ARKANSAS NUCLEAR ONE, UNIT 2

AMENDMENT TO FACILITY OPERATING LICENSE

Amendment No. 70
License No. NPF-6

SAFETY EVALUATION BY THE OFFICE OF NUCLEAR REACTOR REGULATION
RELATED TO AMENDMENT NO. 70 TO FACILITY OPERATING LICENSE NO. NPF-6

FIGURE 3.1 - 1A

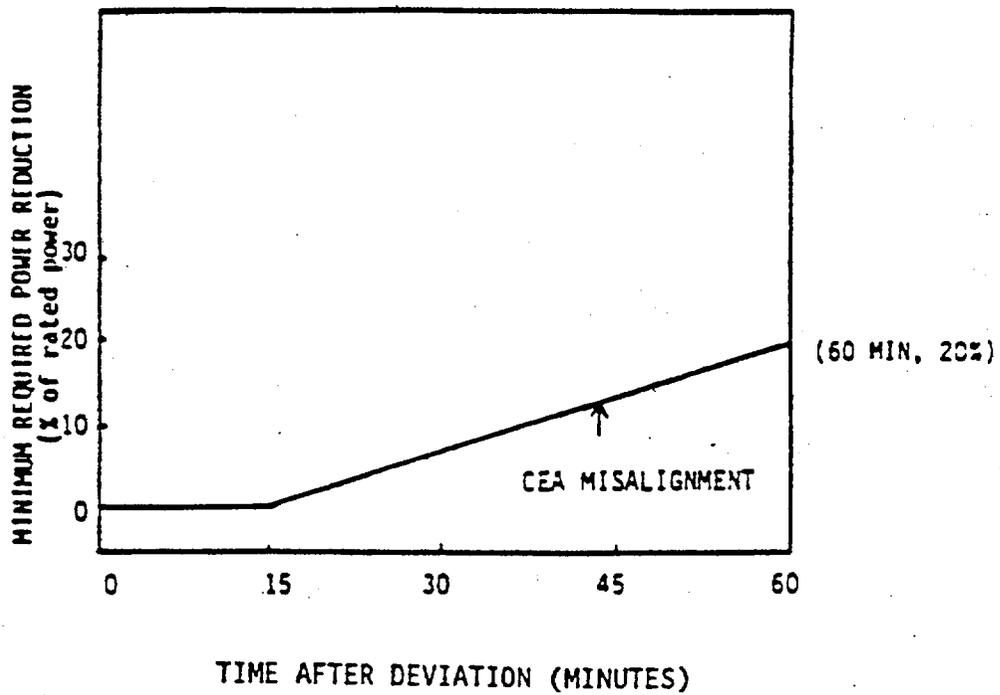
- (1) Revision of Technical Specification 3.1.3.1 by adding a new Figure 3.1-1A which requires a power reduction when one or more full length or part length CEAs is misaligned from other CEAs in its group by a certain length.
- (2) Revision of Figure 3.2-4 in Technical Specification 3.2.4, Limiting Condition for Operation on DNBR Margin, by increasing the DNBR margin operating limit by 0.1 in DNBR.
- (3) Deletion of a redundant requirement in Surveillance Requirement 4.1.3.1.1 which required the CEA position to be verified once per 4 hours when one or two CEAs are inoperable.

Technical Specification 3.1.3.1, Limiting Condition for Operation on Movable Control Assemblies, will be revised. The revision is to add a new Figure 3.1-1A and add an additional requirement in Actions d and e for a power reduction in accordance with Figure 3.1-1A for the reactor operation to be continued when one or more full length or part length CEA's are misaligned from other CEA's in its group by the specified length. This revision in essence is more restrictive than the existing Technical Specification. However, since the purpose of this additional restriction is to compensate for the planned reduction in the CPC inward CEA deviation PFs to 1.0, the increased operating safety margin resulting from this added restriction must be large enough to compensate for the safety margin degradation resulting from the reduction of the inward CEA deviation PFs. Even though the same approach has been made and approved for San Onofre Units 2 and 3, the staff requested an analysis specific to ANO-2. In response to a staff question, the licensee provided a brief analysis (Ref. 2). It shows that the required overpower margin reserved by the COLSS (Core Operating Limit Supervisory System) power operating limit provides sufficient margin to compensate for the penalty factors required for the first 15 minutes after a CEA deviation. After 15 minutes, the ROPM is not large enough to compensate for the required CEA deviation PF resulting from the dynamic xenon redistribution and therefore a power reduction is required. The analysis also shows that the combination of the COLSS ROPM and the power reduction in accordance with Figure 3.1-1A is large enough to compensate for the required PFs beyond 15 minutes of the CEA deviation. Therefore, continued operation in accordance with the proposed Technical Specification change to LCO 3.1.3.1 provides assurance that the specific acceptable fuel design limits will not be exceeded subsequent to an inward CEA deviation event. The proposed change to Technical Specification 3.1.3.1 is thus acceptable.

- d. With one or more full length or part length CEAs misaligned from any other CEAs in its group by more than 7 inches but less than or equal to 19 inches, operation in MODES 1 and 2 may continue, provided that core power is reduced in accordance with Figure 3.1-1A and within 1 hour the misaligned CEA(s) is either:

e. With one full length or part length CEA misaligned from any other CEA in its group by more than 19 inches, operation in MODES 1 and 2 may continue, provided that core power is reduced in accordance with Figure 3.1-1A within one hour the misaligned CEA is either:

FIGURE 3.2-4

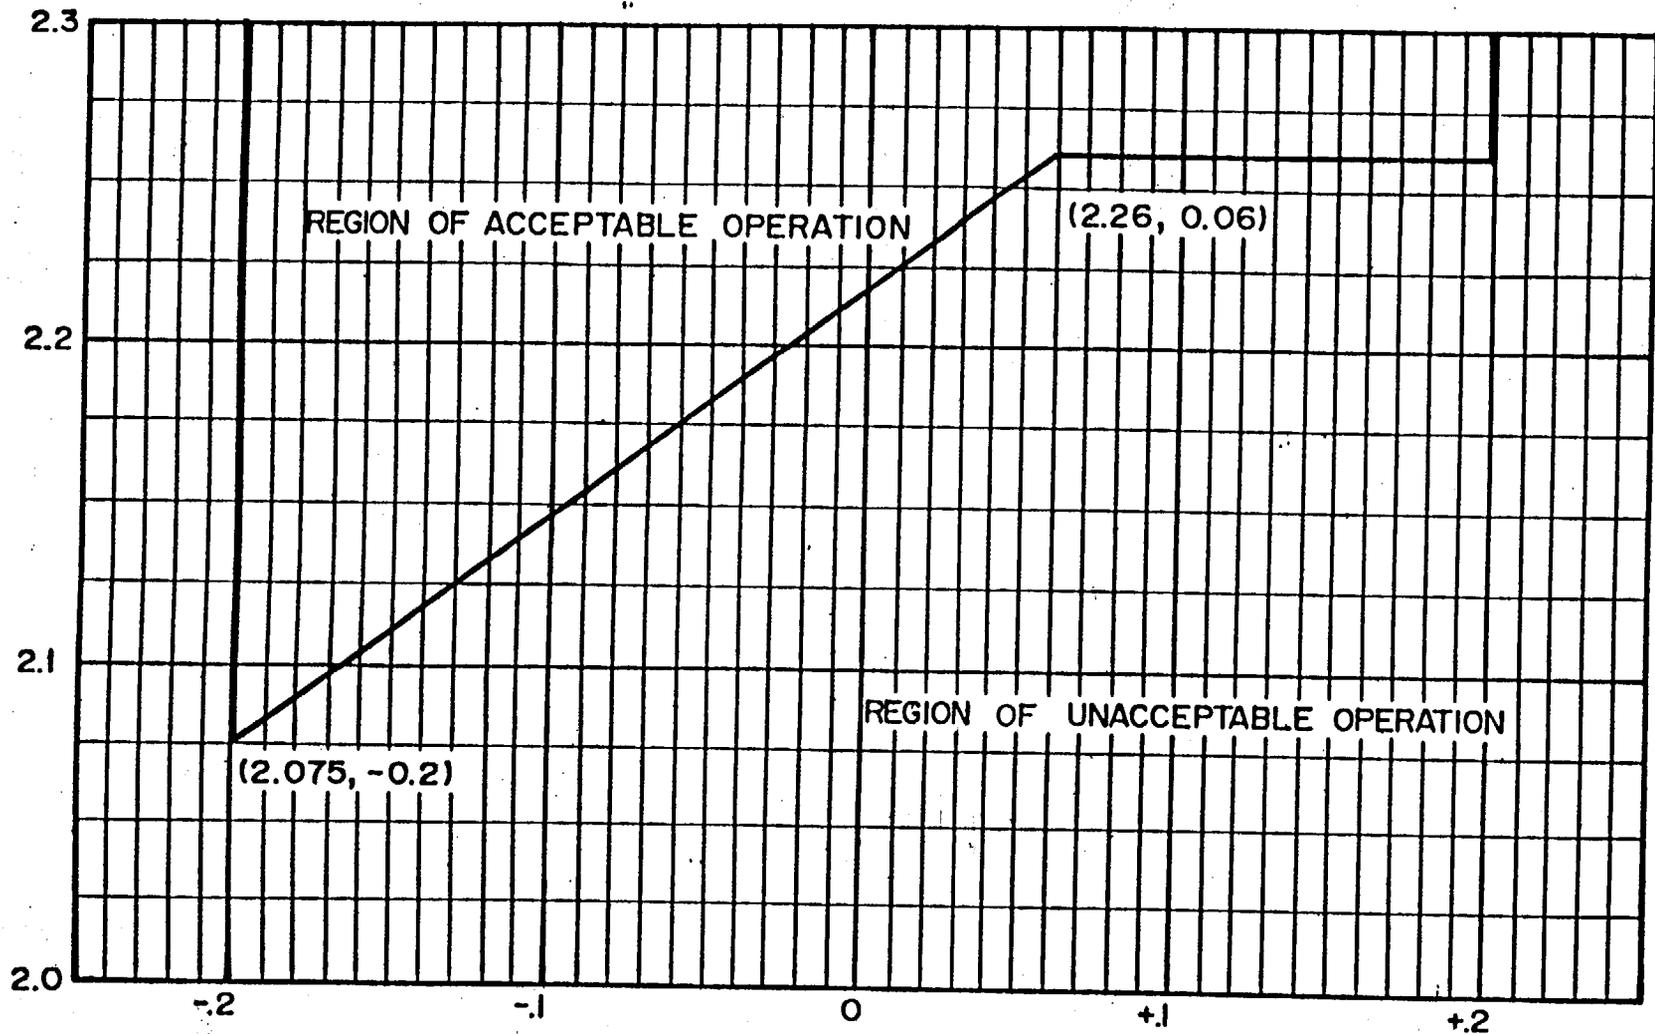
Technical Specification 3.2.4, Limiting Condition for Operation on DNBR margin, will be revised by modifying Figure 3.2.4. Figure 3.2.4, DNBR margin Operating Limit based on CPCs, specifies the minimum allowable DNBR calculated by CPC as a function of axial shape index (ASI) when COLSS is out of service. The modification increases the minimum allowable DNBR by 0.1. This revision, in essence, imposes a more stringent limit on the LCO. However, this additional restriction is necessary since the COLSS required overpower margin is not available when the COLSS is out of service. The licensee has determined that limiting the reactor operation in accordance with the new Figure 3.2-4, provides sufficient margin to compensate for the required inward CEA deviation PFs, and therefore the SAFDLs will not be exceeded for an inward CEA deviation event. Therefore, we conclude that the proposed change to Figure 3.2.4 is acceptable.
